Subject: Submittal Supporting Accelerated ABWR Review Schedule - **DFSER**  
**Chapters 3 and 6 Outstanding Items and Question Response**

Enclosed are SSAR markups addressing Confirmatory Items 3.6.1-2 and 6.2.1.7-1, and response to Open Item 6.2.1.6-3. In addition, the response to a question on Subsection 6.2.1.2.2 Design Features is enclosed.

### **DFSER OPEN ITEM 6.2.1.6.3: CONTAINMENT MODELING CONCERN**

Response to Question  
on subsection 6.2.1.2.2

FIGURE 6.2-37C-3. SECONDARY CONTAINMENT SCHEMATIC FLOW DIAGRAM. (REACTOR WATER CLEAN UP SYSTEM)

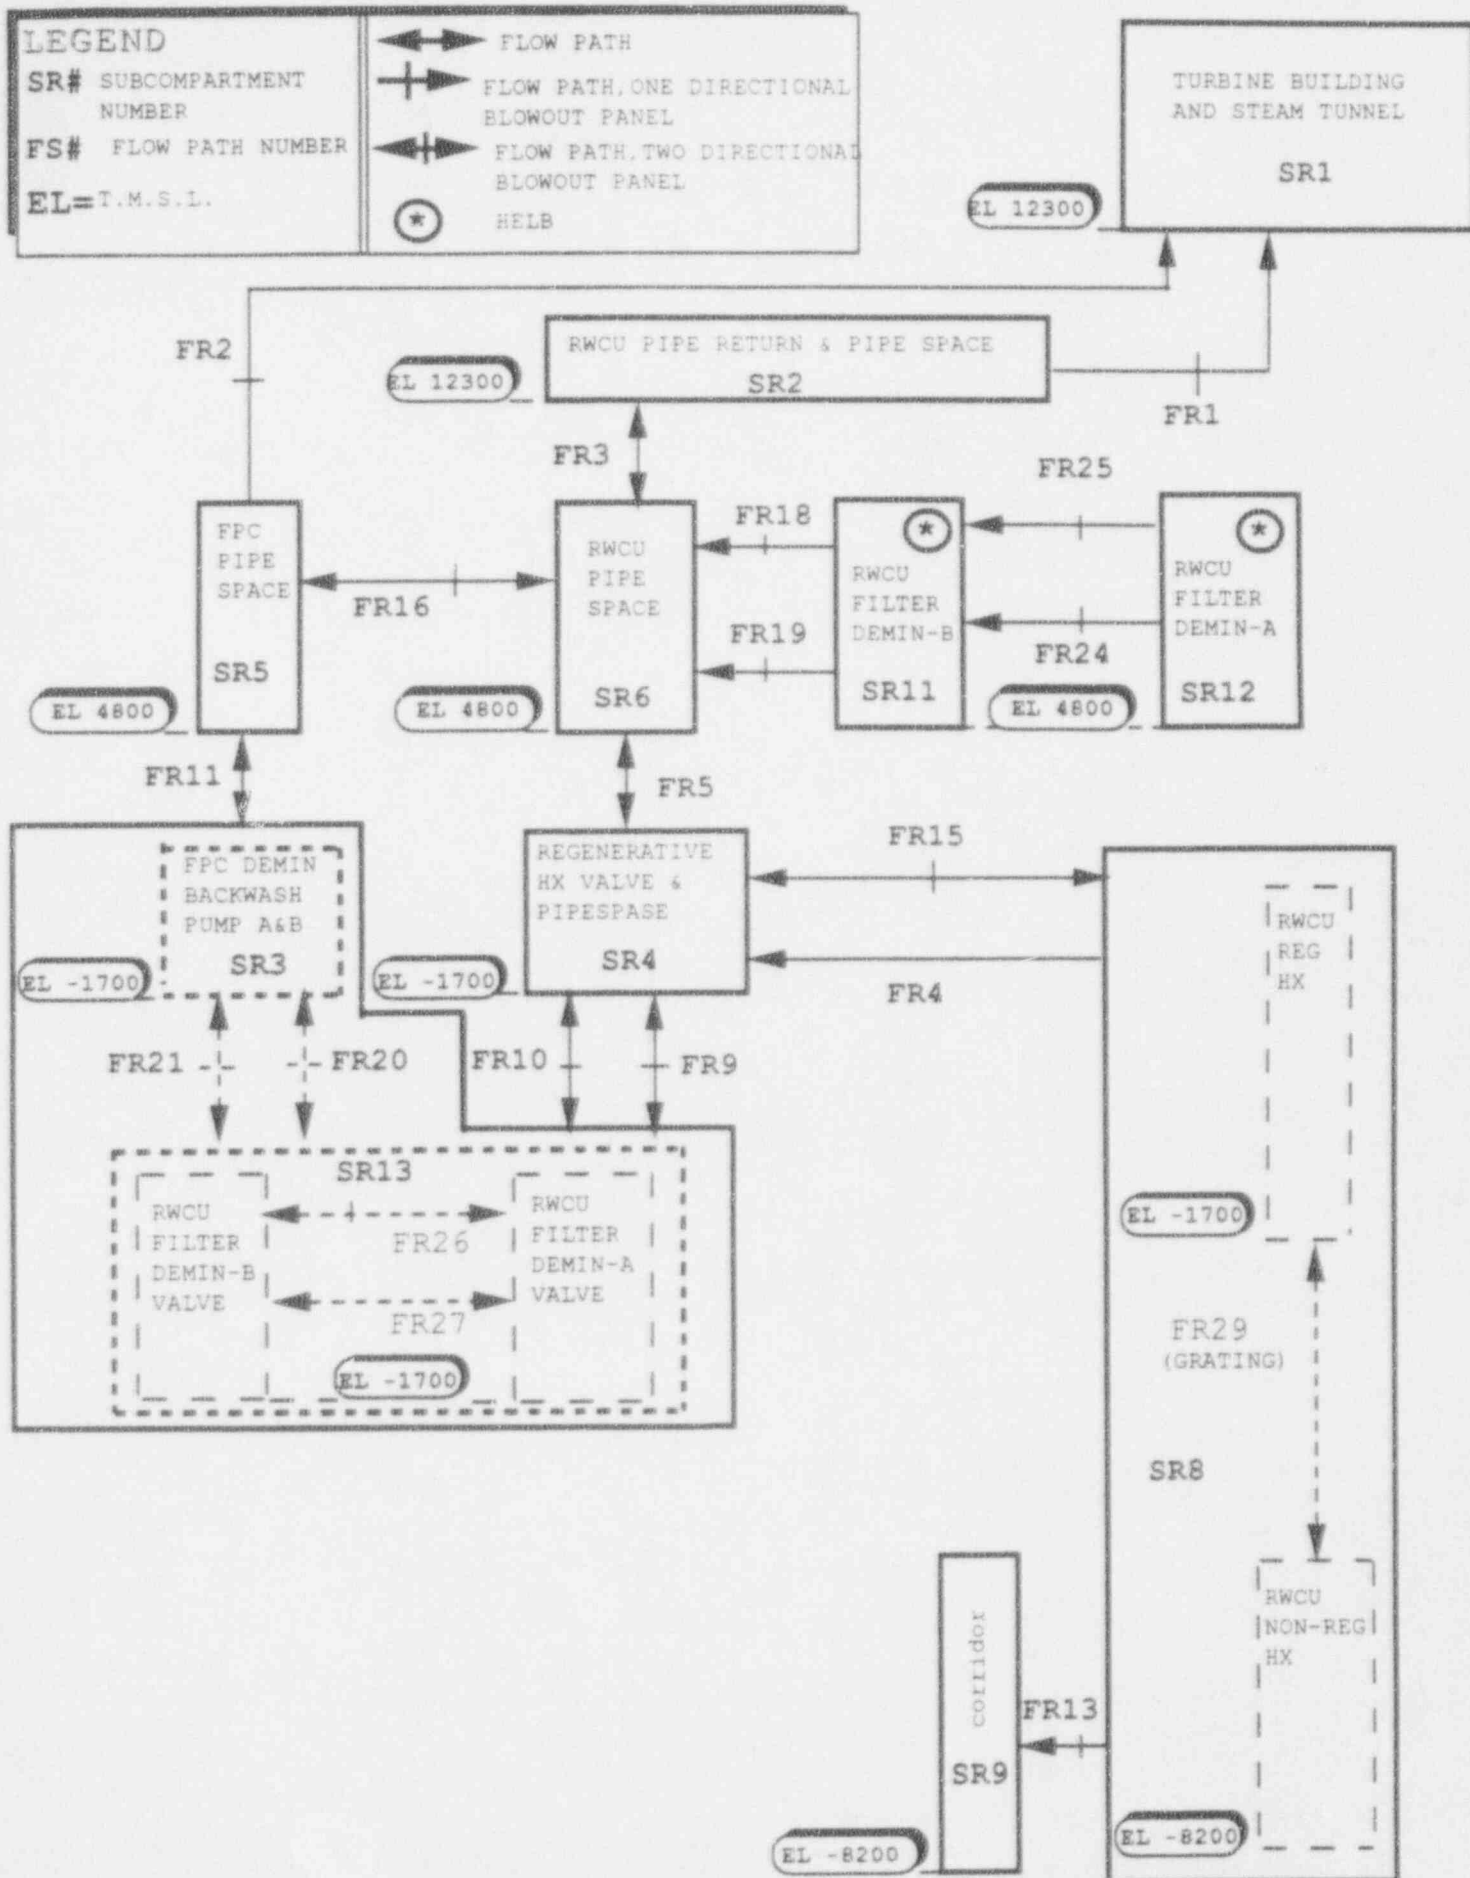
Figures 6.2-37-C1 through 6.2-37-C3 show compartment nodalization scheme for the pressurization analyses for different break cases. Table 6.2-3 shows the free volume, initial environmental conditions and DBA characteristics for the compartments which were analyzed. Table 6.2-4 tabulates subcompartment vent path characteristic. The calculated peak differential pressures for the RWCU compartments are tabulated in Table 6.2-3

Break in subcompartment SR11  
and SR12 RWCU Filter/Demin B Room  
RWCU Filter/Demin A or B  
(Figure 6.2.37c-3)

FIGURE 3

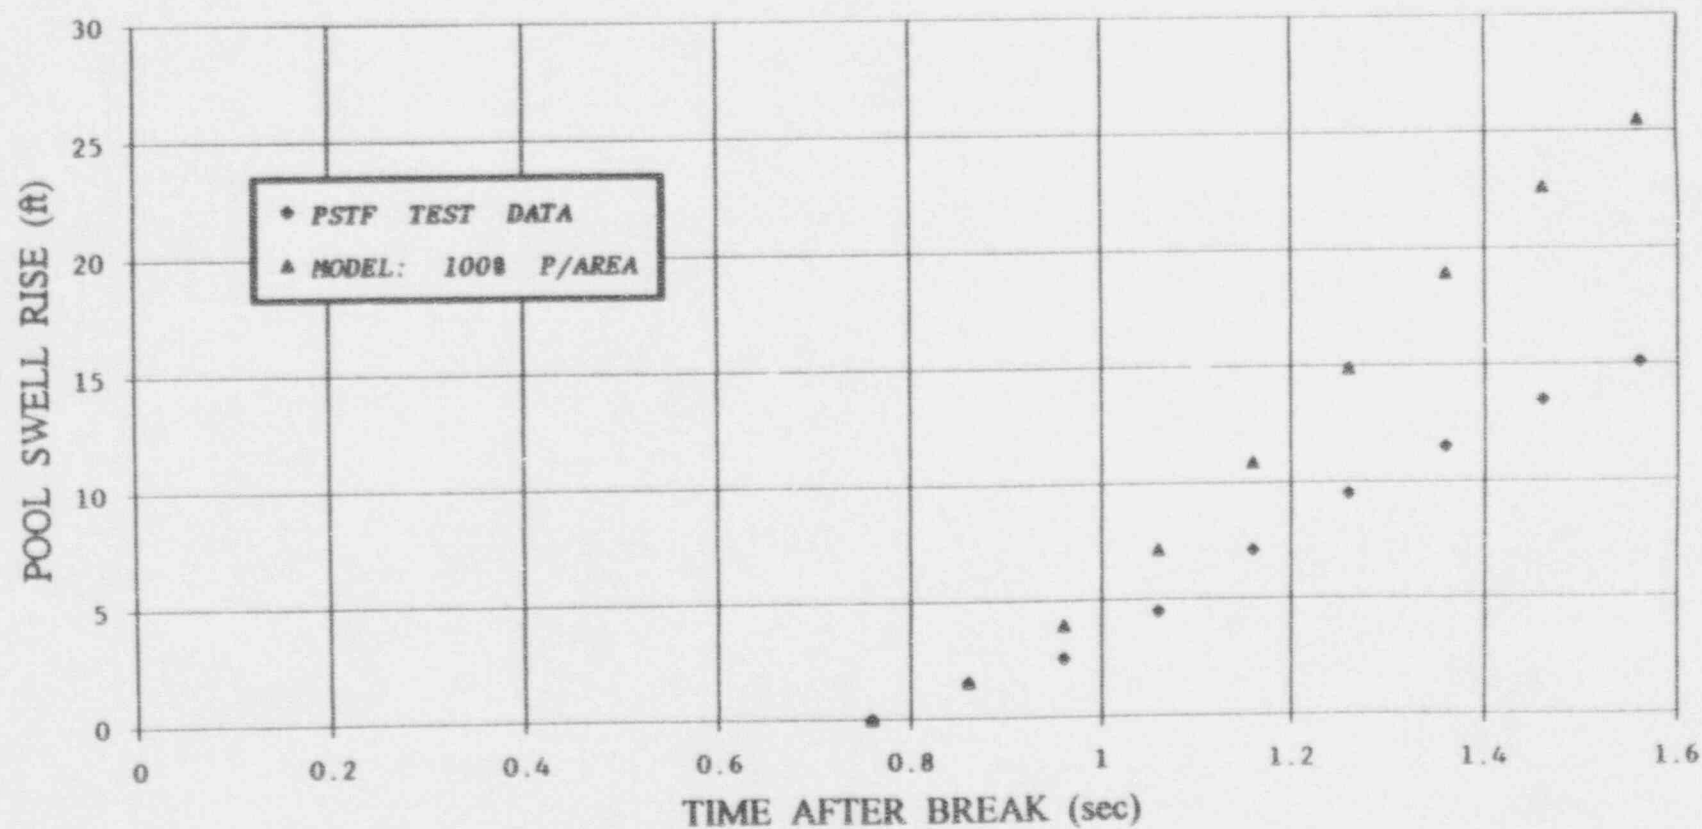
Comparison results, summarized in Table 2 and sample results shown in Figures 3 and 4, demonstrate that the model over predicts the horizontal vent test data. These comparison results demonstrated and assured adequacy of the model for calculating ABWR pool swell response.

FIGURE 8

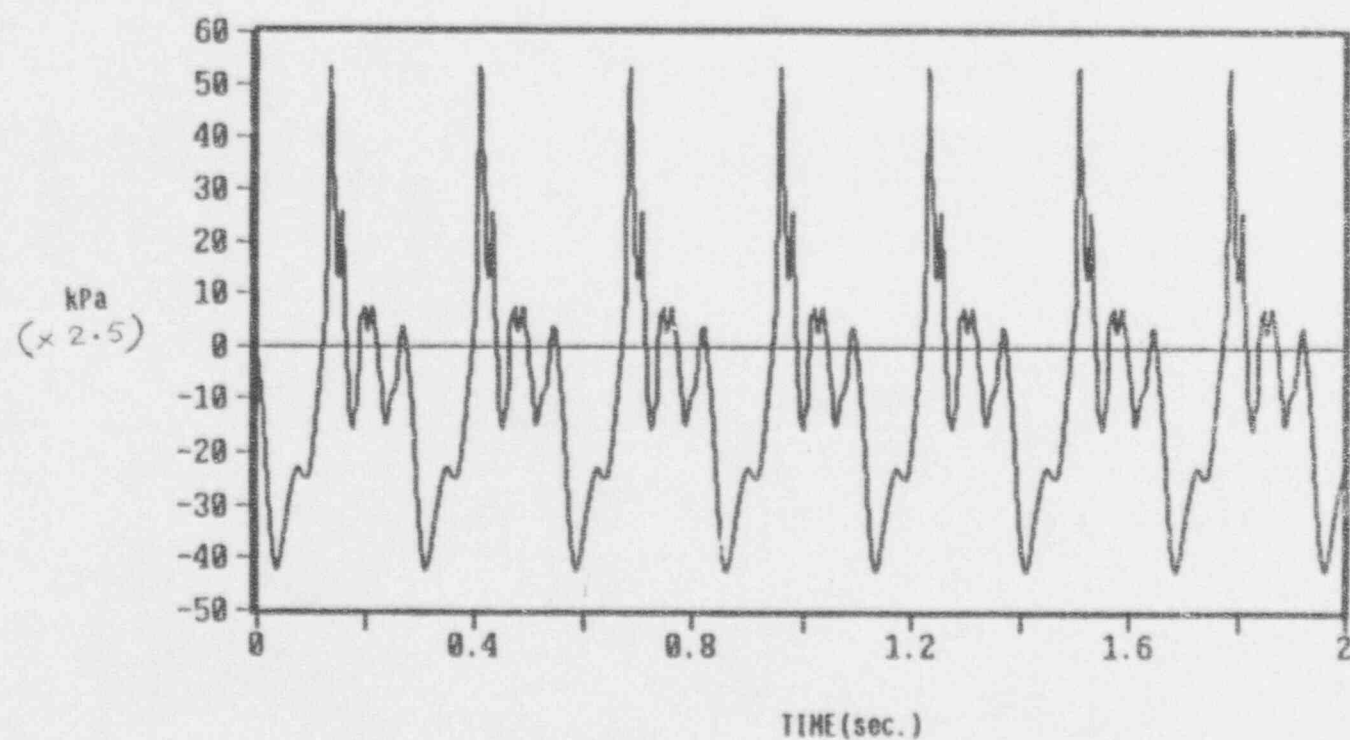
Figure 8 shows pressure time history representative of ABWR CO load determined using the source load approach described above. Figure 9 shows pressure time history representative of Mark III CO loads. This pressure time history is based on Mark III CO correlation described and discussed in GFSSAR. In comparison, ABWR pressure amplitudes are higher than for Mark III design.

FIGURE 11

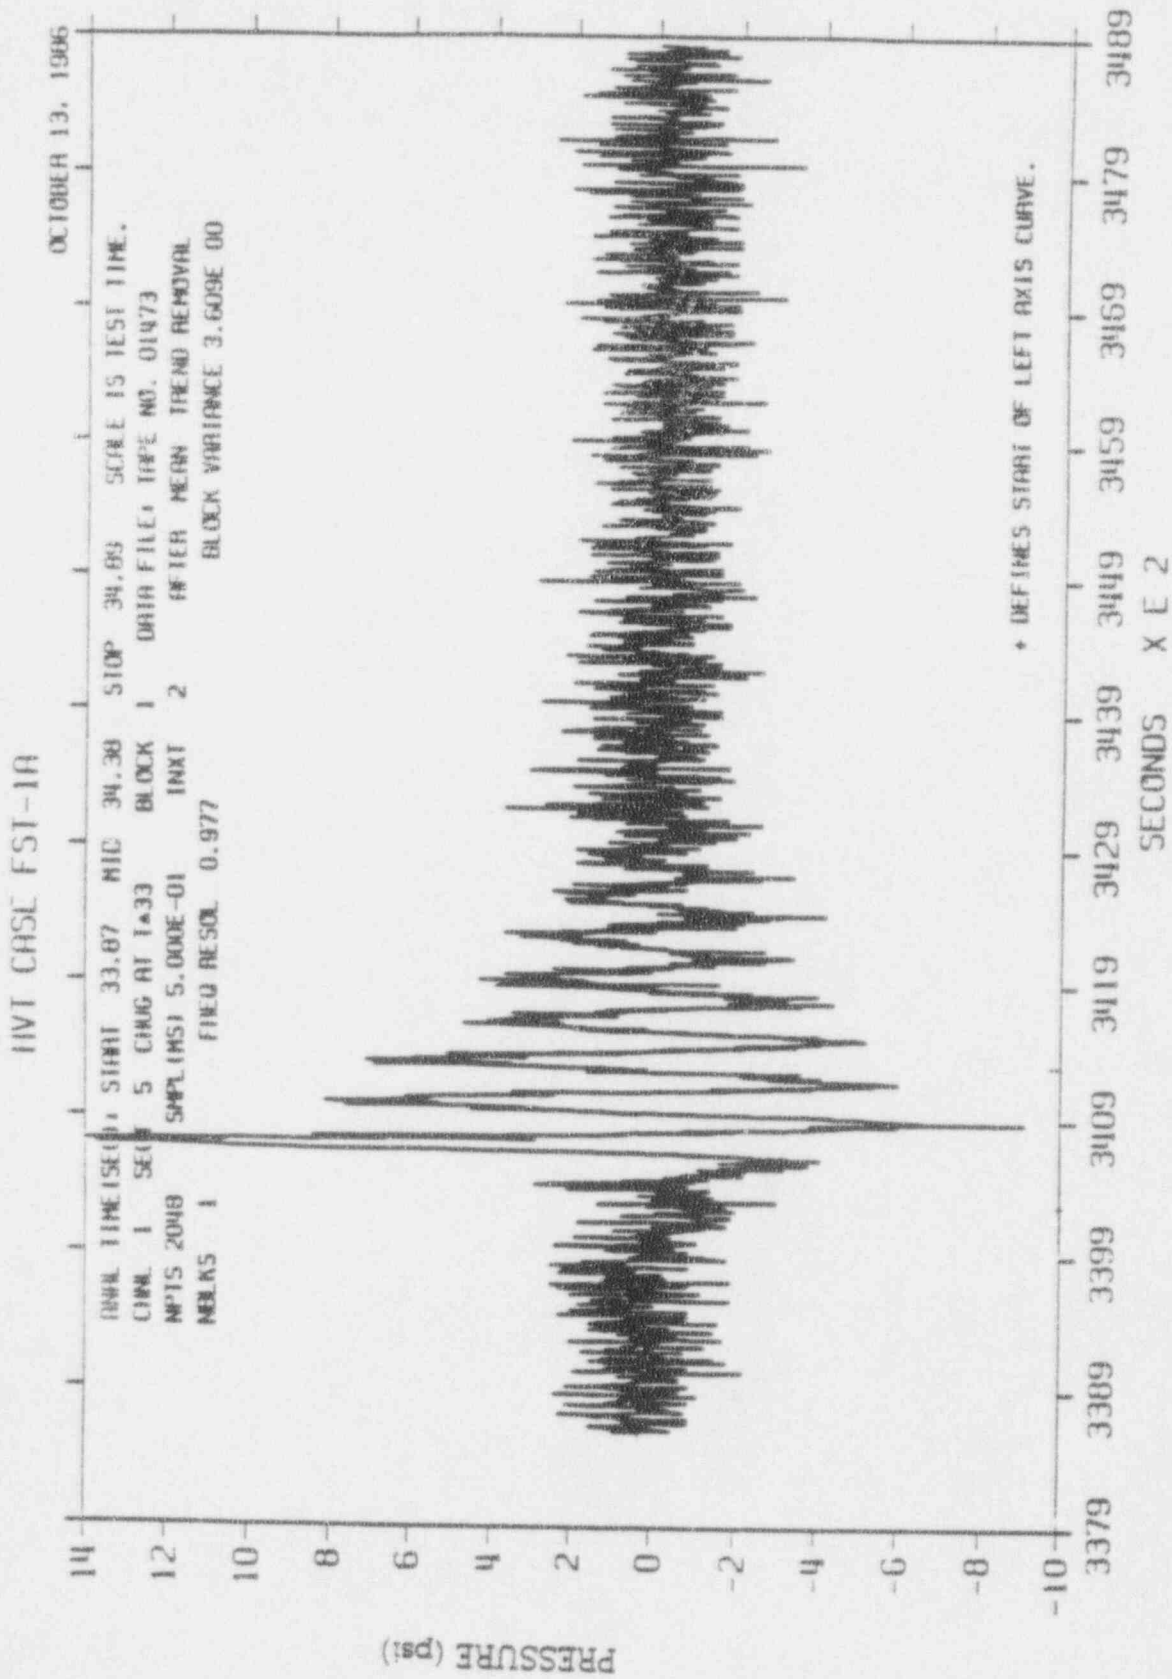
Basic characteristic features of a typical large chug from the FS\* testing, shown in Figure 11. It is characterized by a small underpressure, followed by a positive pressure pulse, and a decaying ringout. Chugging data from Mark II and Mark III testing also exhibited similar features.
